**CAMDEN FAMILY HEALTH
WEBSTER COUNTY, WEST VIRGINIA
CAMDEN FAMILY HEALTH ADMINISTRATIVE OFFICES
ADDENDUM #1**

**APRIL 1, 2026
THRASHER PROJECT #T60-11021**

A **MANDATORY** Pre-Bid Conference was held on Wednesday, March 18, 2026, on the above-referenced project, a copy of the sign in sheet is included in this Addendum. The following are clarifications and responses to questions posed by contractors for the above-referenced project.

WALL PROFILE

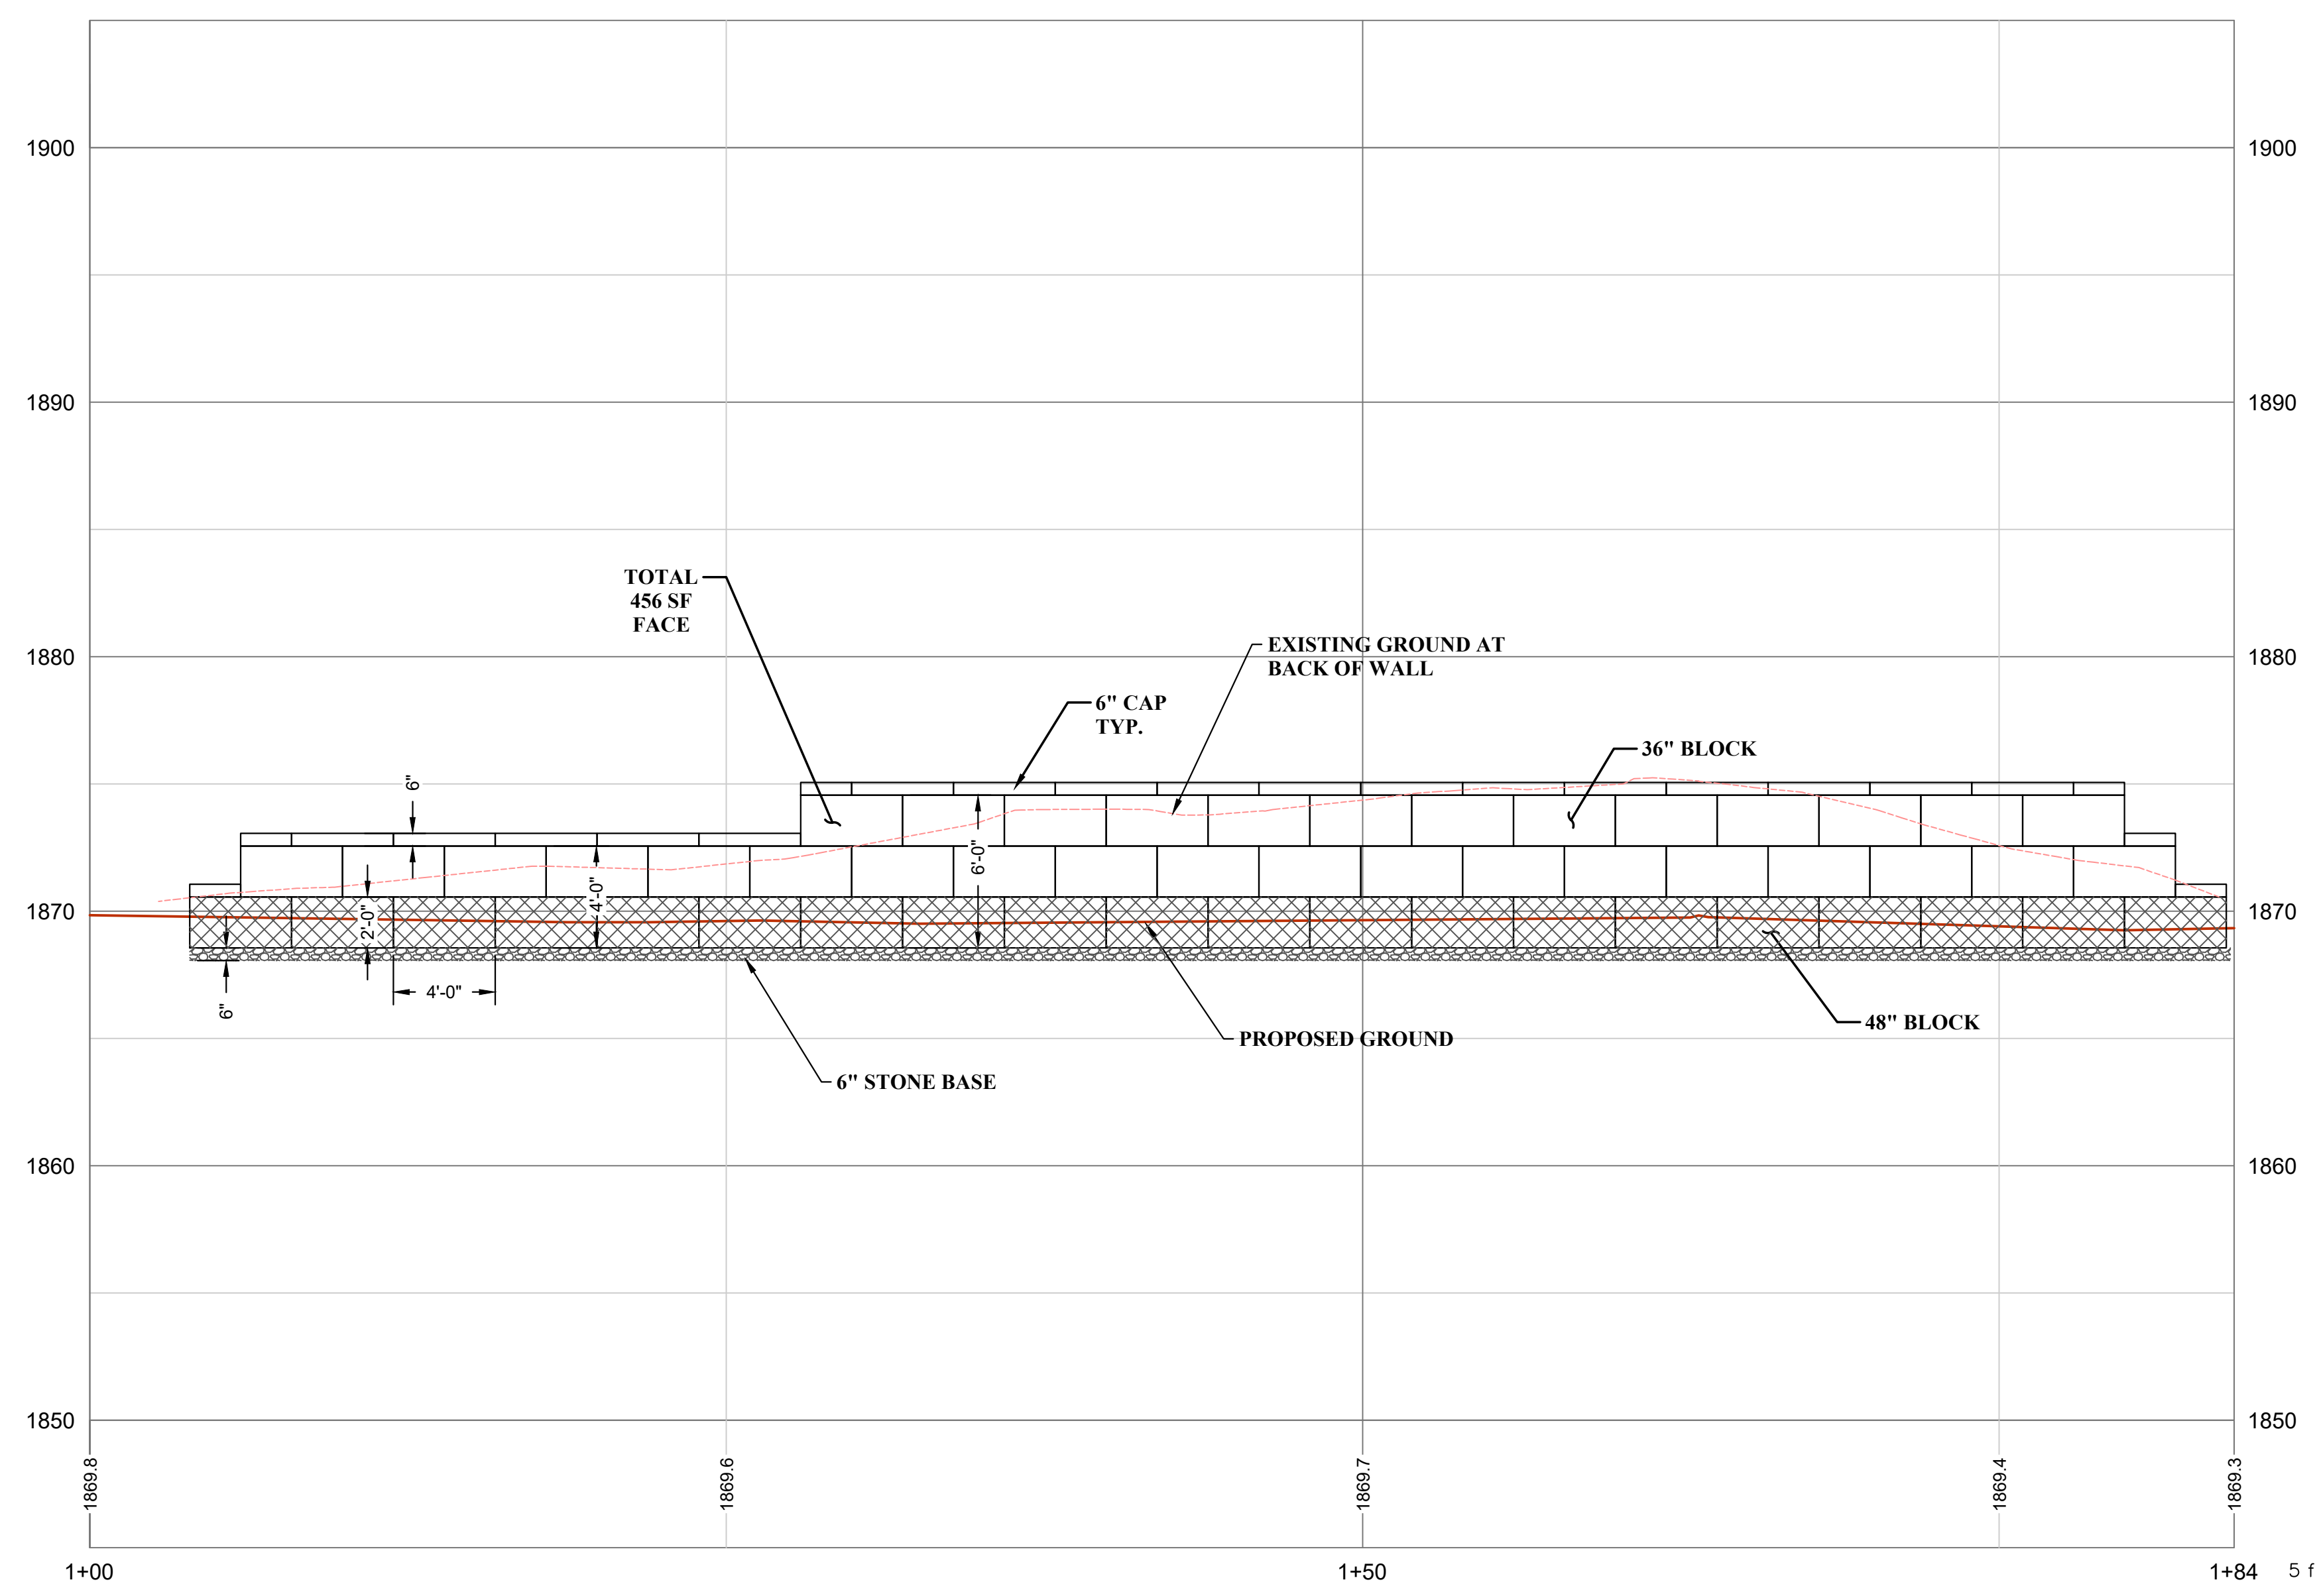
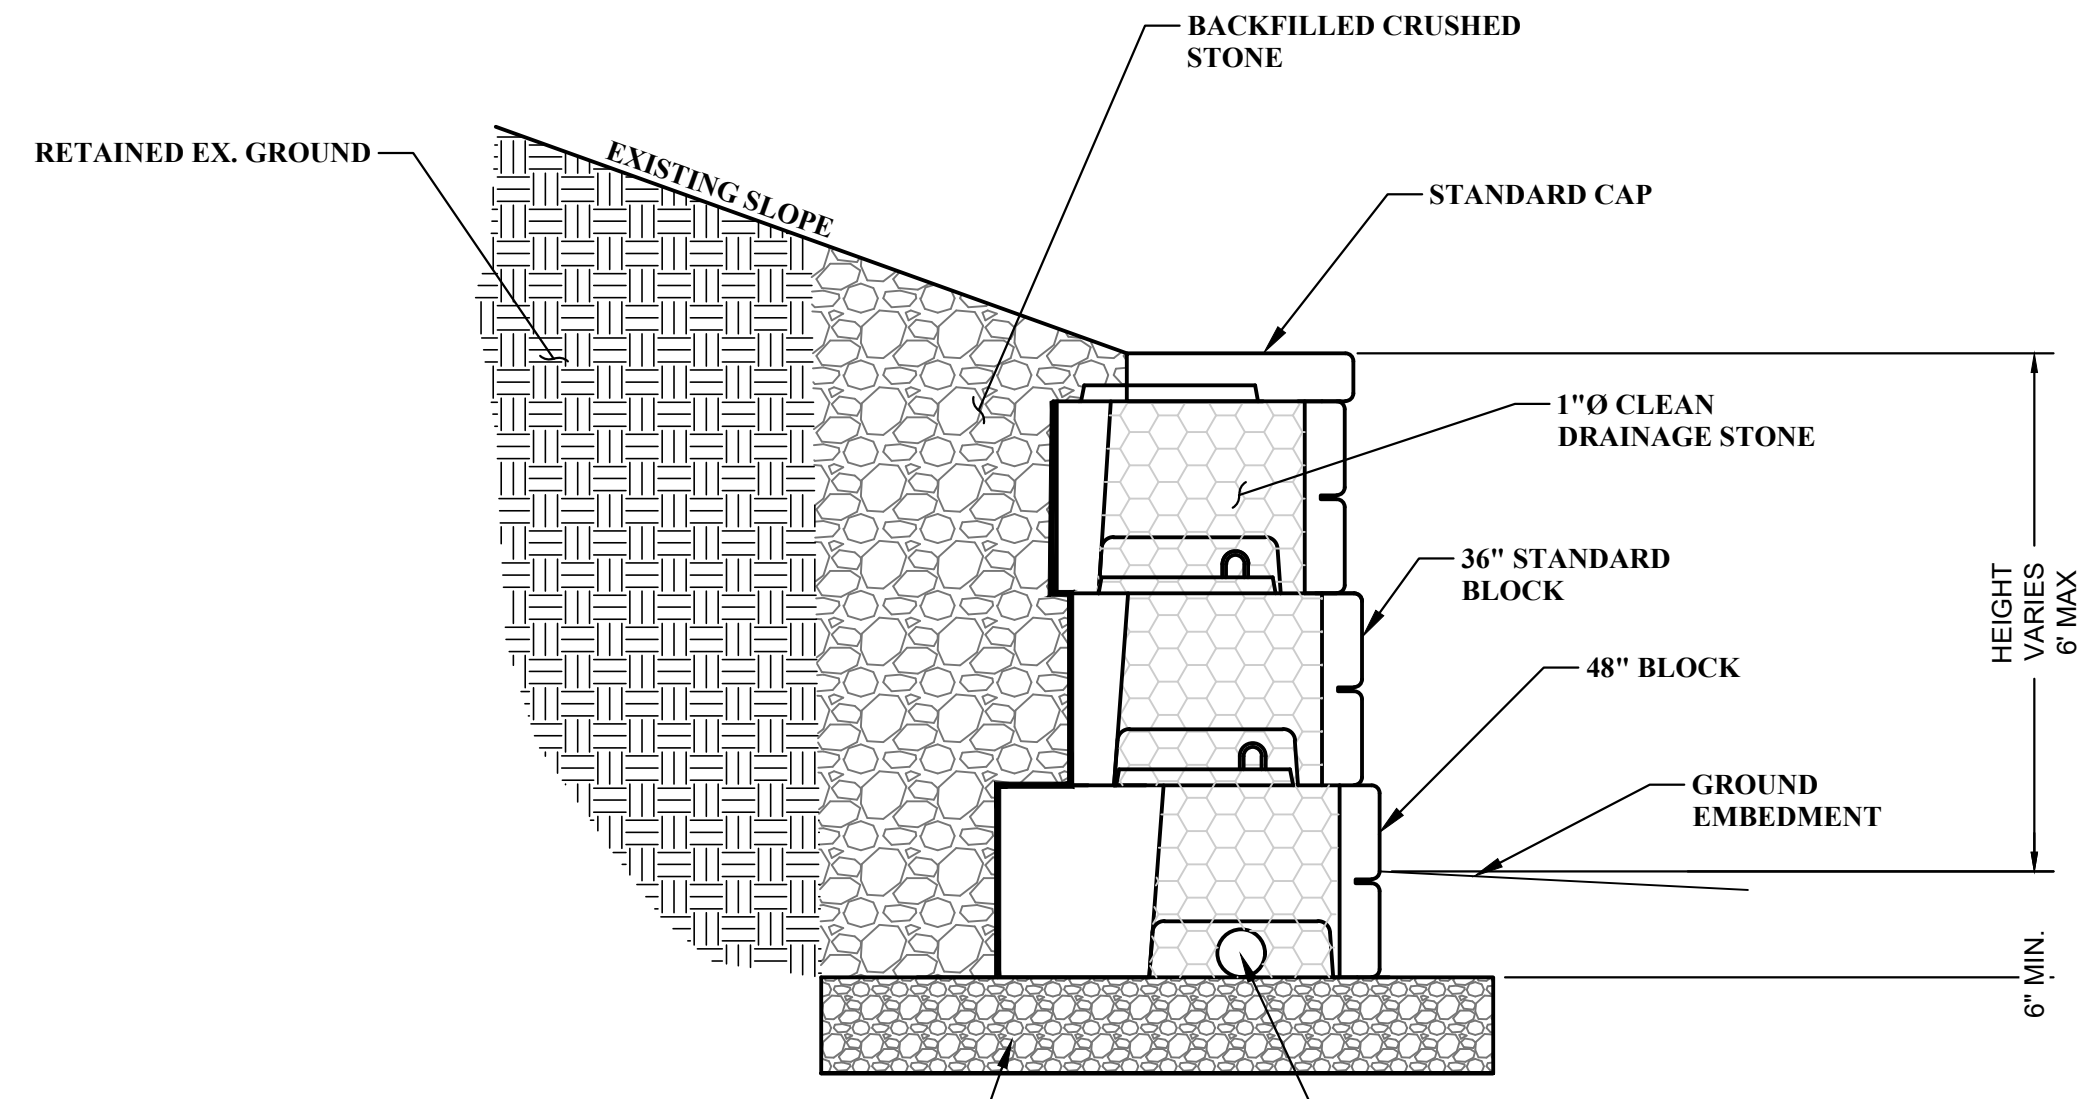
Sheet C3.02 Typical Retaining Wall Section, can a scaled drawing be provided with the length, width, and height.

A profile of the proposed retaining wall has been provided in the detail sheets.

DUMPSTER PAD DETAIL
NOT TO SCALE

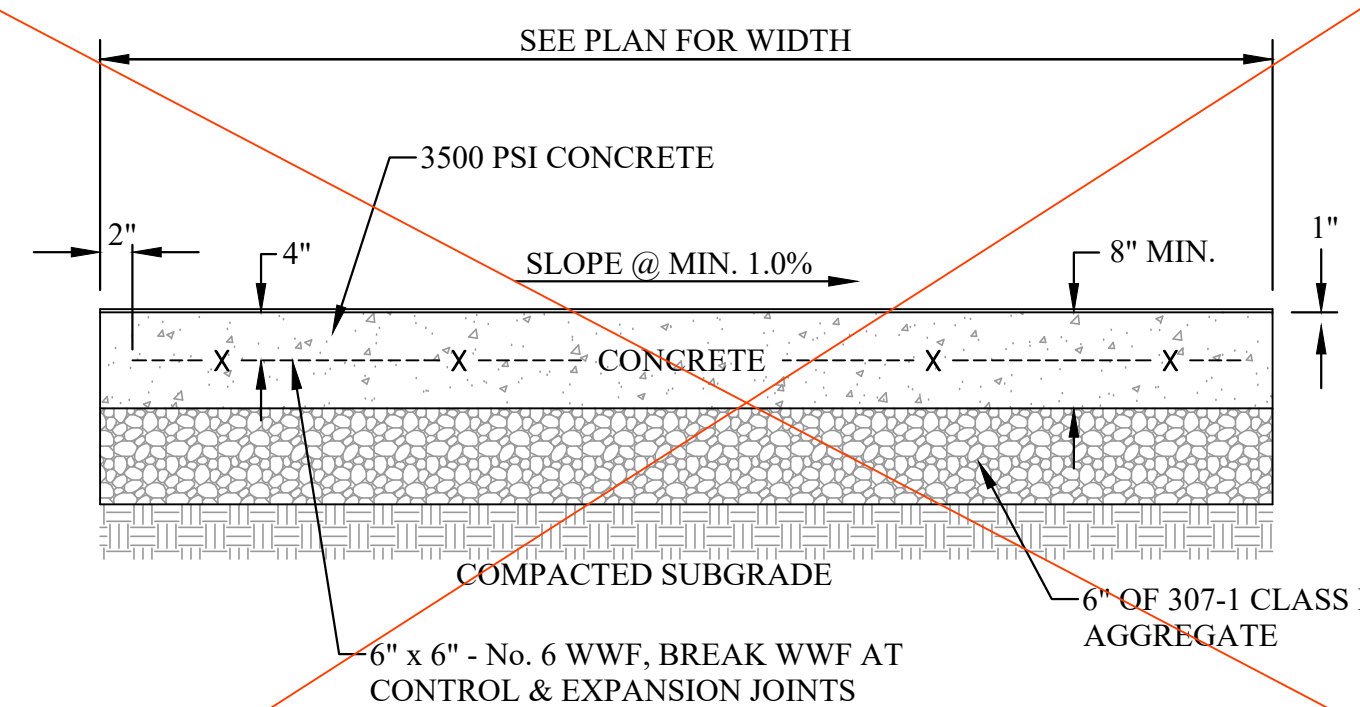
Sheet C3.02 shows a detail for the dumpster pad, but no location shown on Sheet 2.01.

Reference Sheet C.2.02 – There is a detail on a Dumpster Pad, but none shown on Sheet C2.01. Please clarify & if it is included, please provide details on the wall construction of enclosure.

Ignore dumpster pad detail, there is not a dumpster pad on the project.

Ignore dumpster pad detail, there is not a dumpster pad on the project.

STEEL BOLLARD
NOT TO SCALE

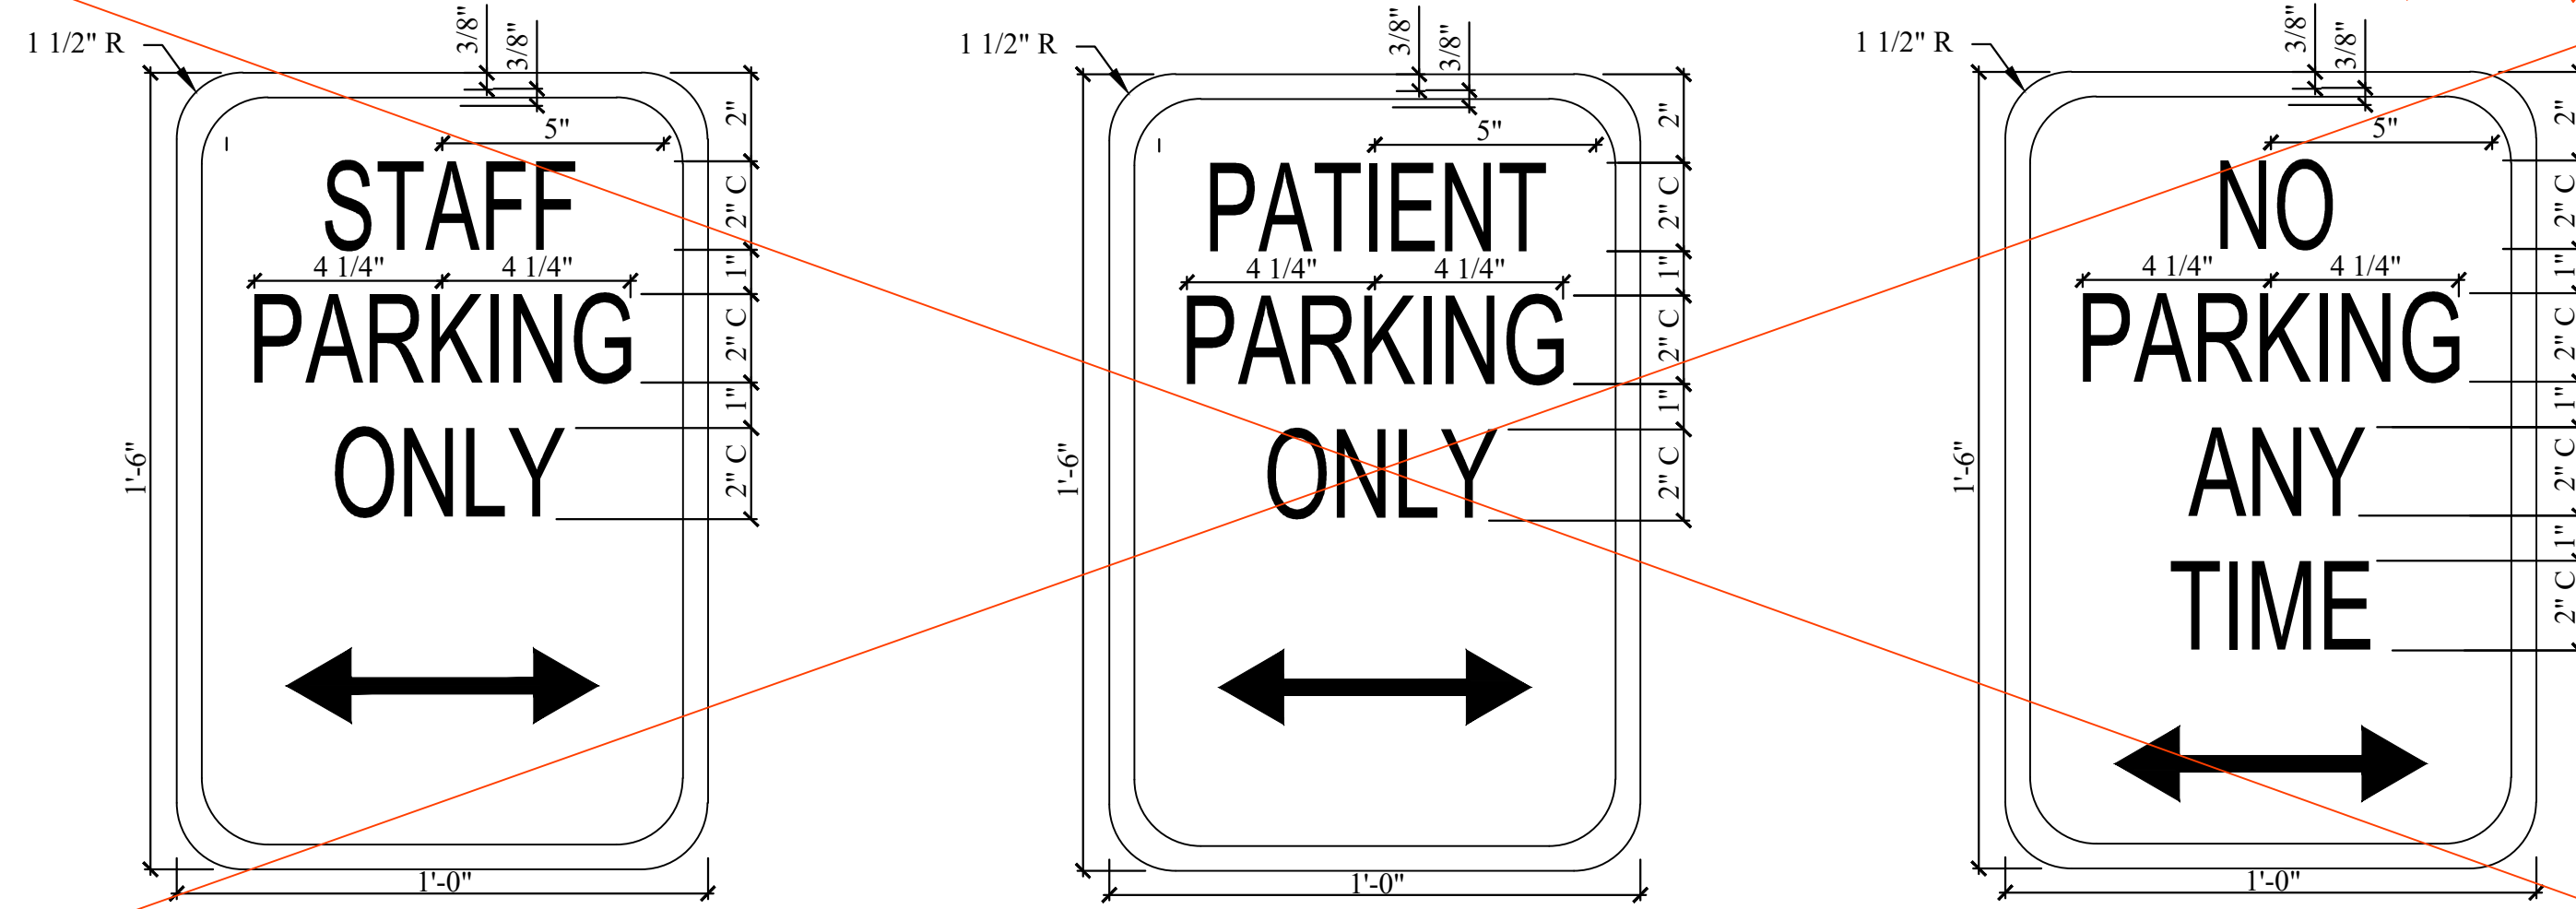
Sheet C3.02 shows a detail for bollards, but no location shown on Sheet C2.01.

Reference Sheet C3.03 – There is a detail for Bollards, but none shown on Sheet C2.01. Please clarify or indicate counts.

The bollards will be in front of the drop off area and shall be a steel bollard with a stainless-steel cover.

The bollards will be in front of the drop off area and shall be a steel bollard with a stainless-steel cover.

RUBBER PARKING BUMPER @ ADA STALLS
NOT TO SCALE

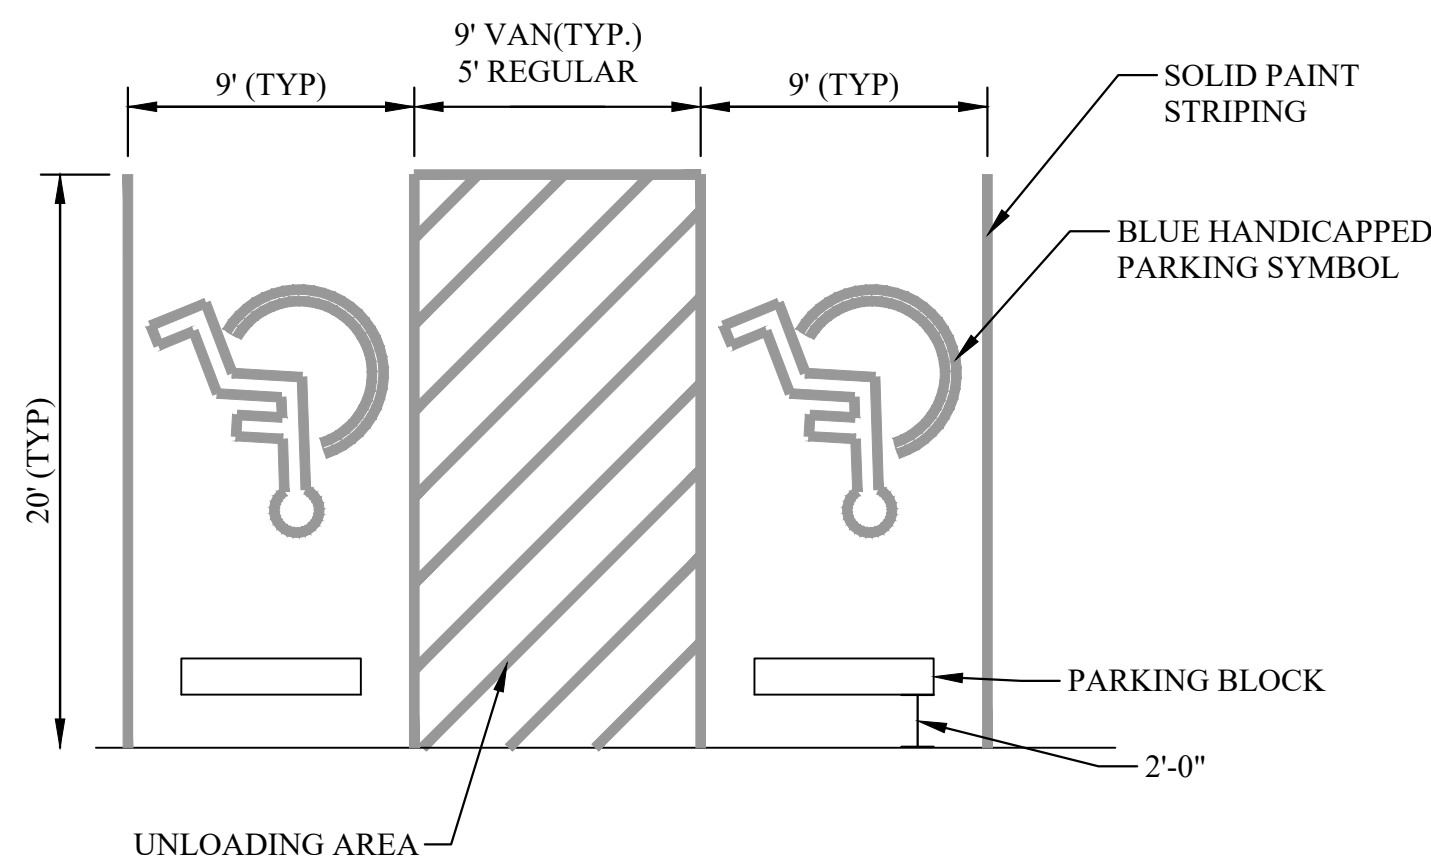
Sheet C2.01 shows parking blocks in ADA sections only. Are these desired in any other location?

Reference Sheet C2.01 – Please clarify if every parking space is to receive wheel stops or just the handicap parking spots.

Yes, only at the ADA parking spots.

Only at the ADA parking spots.
